SERVICE BULLETIN

SUBJECT: ROLLERGAMES Upper Diverter Assembly Improvements

Upper Diverter Assembly
p/n C-13489 , Rev. C

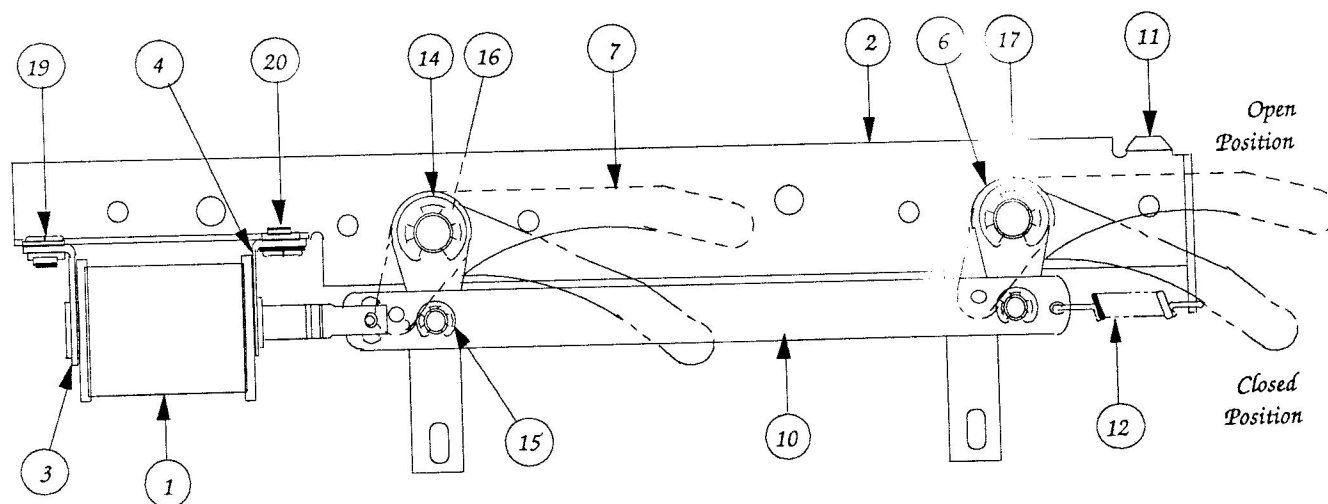
Information: Improvements to the Upper Diverter Assembly, p/n C-13489, include (1) a coil change (replace the AE-23-800 coil with one marked AE-26-1200); (2) a Solenoid Bracket Assembly, p/n B-13488, change; and (3) a change to the assembly comprising the coil plunger, drive link, and spring.

It is suggested that these changes can occur in the order listed in the preceding paragraph; that is, coil replacement should be first, followed by replacing the Solenoid Bracket Assembly. If necessary, the more complex change of the coil plunger, drive link, and spring should resolve all associated problems with the Upper Diverter Assembly.

- A. Unsolder the wires connected to the Coil, noting each wire's coil terminal.
- B. Remove the solenoid bracket Mounting Screws (19), retaining them for reassembly.
- C. Remove the AE-23-800 Coil (1), and replace it with an AE-26-1200 Coil.
- D. Replace the Solenoid Bracket Assembly, p/n B-13488, (3) with a new 'revision A' Assembly. (The revision A Solenoid Bracket Assembly has a slightly shorter solenoid stop than the original assembly.)
- E. Mount the Coil (1) and Solenoid Bracket Assembly (3), as they were on the original unit; install and tighten the bracket Mounting Screws (19), using Loc-Tite.
- F. Solder the wires to the new Coil, connecting them to the proper terminals (noted in step A).

- A. Remove the two "E" Rings attaching the old Diverter Drive Link to the two black, plastic Arm Assemblies; retain these "E" Rings for reassembly.
- B. Remove the spring at the end of the old Drive Link; remove the old Drive Link, including the spring-attached Coil Plunger.

- C. Replace all of the old Drive Link parts (coil plunger, springs, etc.) with the new Link-Plunger-Spring Assembly (10), p/n B-13843, sliding the plunger into the coil and inserting the post of each Arm Assembly (7) into the proper hole of the new Link-Plunger-Spring Assembly.
- D. Attach an "E" Ring on each Arm Assembly post to reassemble the Link-Plunger-Spring Assembly. Slip the loop of the Spring into the hole of the Diverter bracket, where the old spring was removed.
- E. Move the updated Diverter Assembly back and forth several times to verify that it is moving freely, without binding. If necessary, apply a small amount of Williams' Drop Target Grease (or similar lubricant) to the rotating posts on each Arm Assembly.
